AGENDA ITEM 4.a

SUBJECT: Discussion and input on proposed Planning Manager/Director determination on minor modifications to façade and material changes to Land Use Permit located at 1704 Mission Drive (APN 139-240-033).

HOTEL
1704 MISSION DRIVE
SOLVANG, CA 93463

COMMITTEE MEMBER COMMENT RECEIVED AFTER POSTING OF THE AGENDA

CHAPEL AS-BUILT WEST ELEVATION

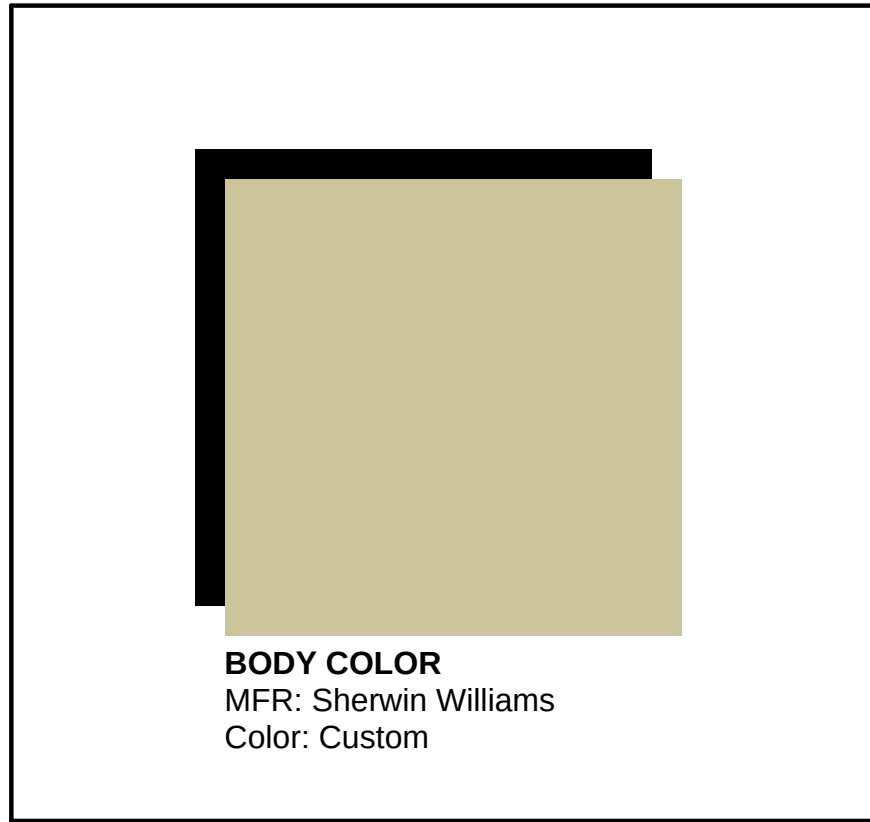
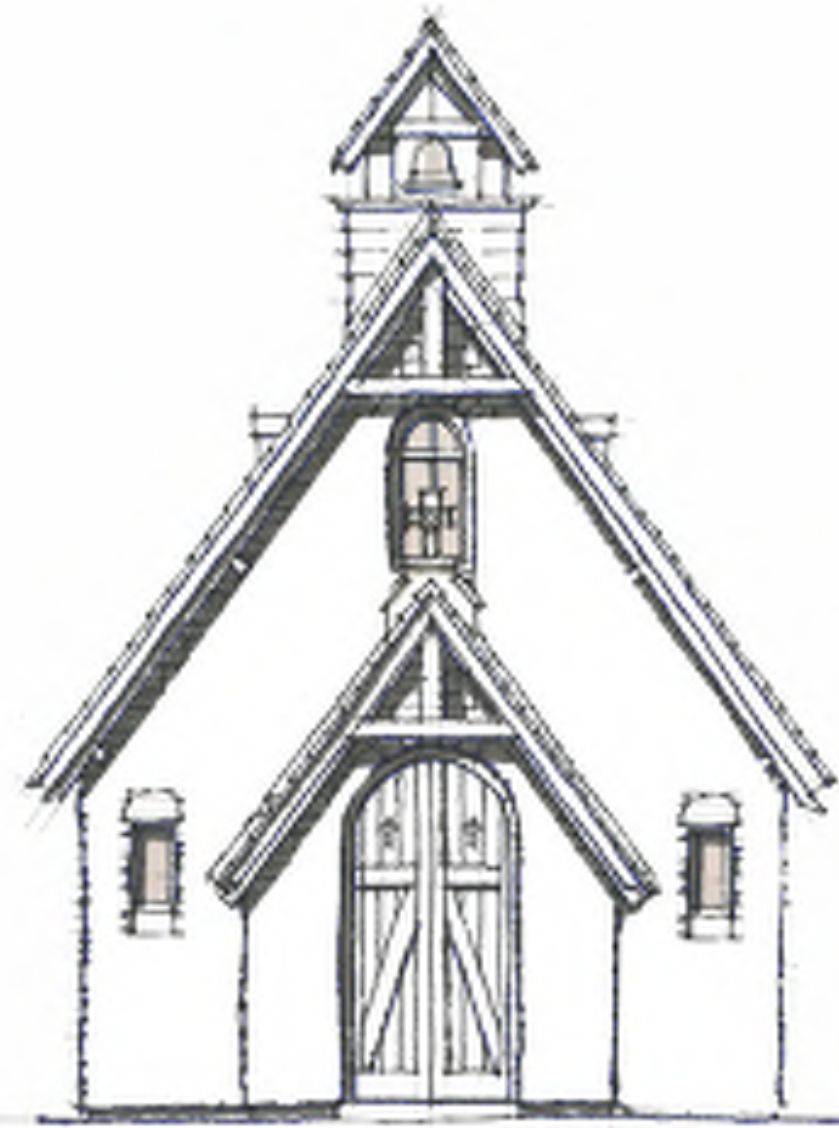
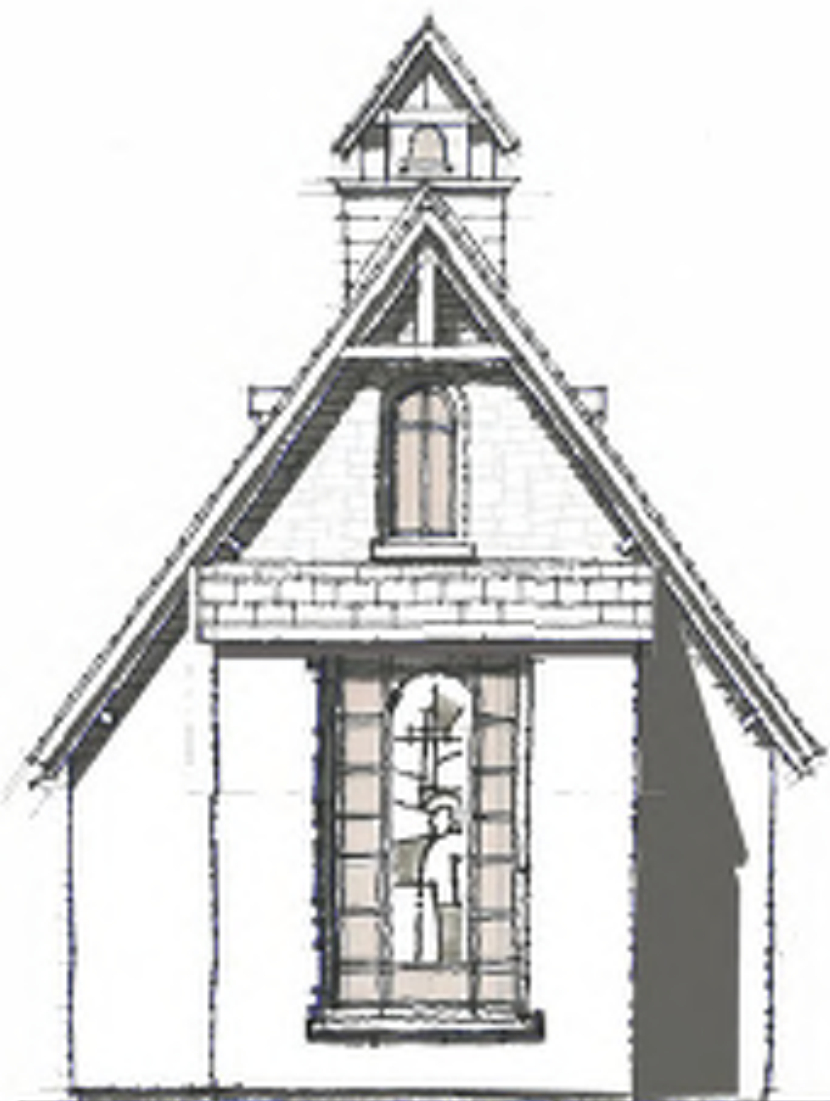
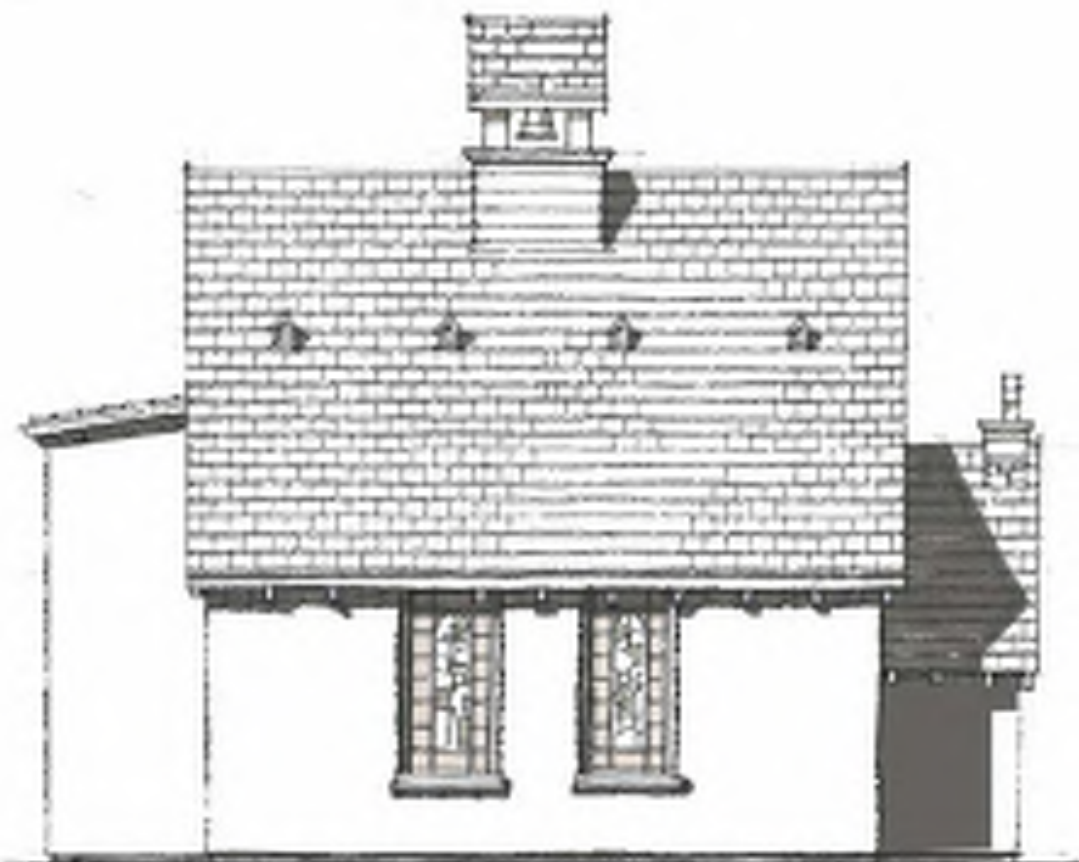
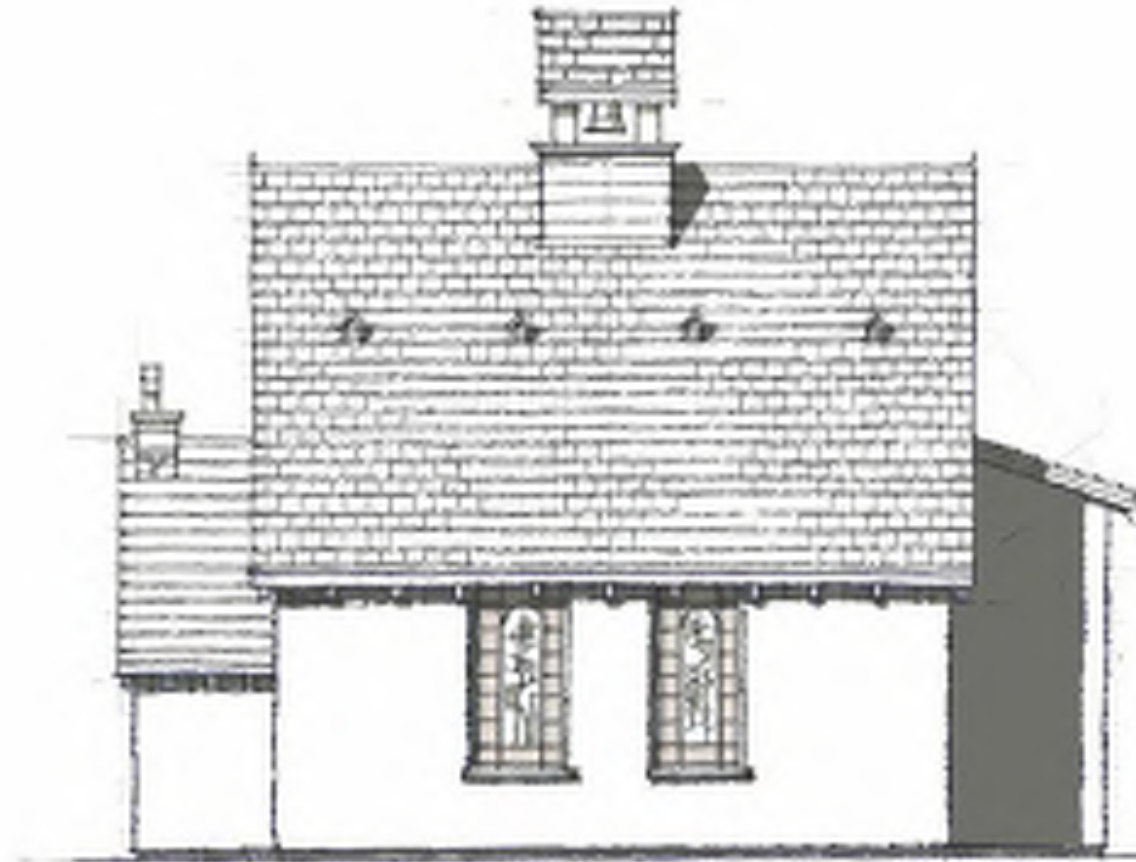
Approved Façade	Proposed Modifications	Director Recommendation
Chapel		
	 BODY COLOR MFR: Sherwin Williams Color: Custom	The applicant has modified the approved elevation, with additional stone, which is typically utilized in “Old World Northern European” design. The chapel building is one of the more prominent buildings in the development. Therefore, the use of stone should be completed on the entirety of the public view shed, which is the north and west elevation. The applicant has only completed stone on the east elevation. The remaining south elevation should be painted an appropriate color, consistent with “Old World Danish” design motif as called for in the adopted documents. Chapels built in Old World Danish style during the 1700s and 1800s typically followed architectural traditions rooted in medieval forms but adapted with regional materials and influences, not necessarily the typical architectural forms seen throughout the City. Colors utilized were white colors, achieved through limewash (calcium hydroxide and water) applied to stone, brick, or other materials. This color evoked qualities symbolic of purity and light. The Limewash helped maintain the color. The proposed color should emulate this old-world Danish style as it is the prominent structure on the site. Keeping with the “Old World Danish” theme, the slate roof, as proposed, should remain one solid color, with the red and white eliminated and maintain the black/charcoal color roof. Director Recommendation Based on the above analysis and pertinent goals and policies, the following is recommended: • Include the use of stone throughout the entire elevations of the north/west sides as visible from the public right of way. • Continued use of stained-glass windows obtained by the applicant that provides character of the structure.

Approved Façade	Proposed Modifications	Director Recommendation
• Stucco wall • Slate roof • Bell Tower • Window and door details • No color proposed, to be selected in the field	• Stucco wall remains • Proposed use of stained-glass on all elevations • Slate roof with color slate variant of red and white versus the approved black • Elimination of Bell Tower • Use of stone on east elevation and portions of west, south and north, limited to base only. • Use of sandstone color	• Elimination of the existing color banding on the roof that includes the red and white Danish flag colors. Roof color shall remain charcoal grey/black • Revised proposed chapel structure color to the colors below. The colors include either a green or grey tint to evoke the limestone color finish of prominent religious structures. An alternative color may be proposed by the applicant and approved by the Community Development Director upon consultation. Green Glimpse SW 9676 #e5e7e2 High Relfective White SW 7757 #f5f7ef White Snow SW 9541 #f1efeb
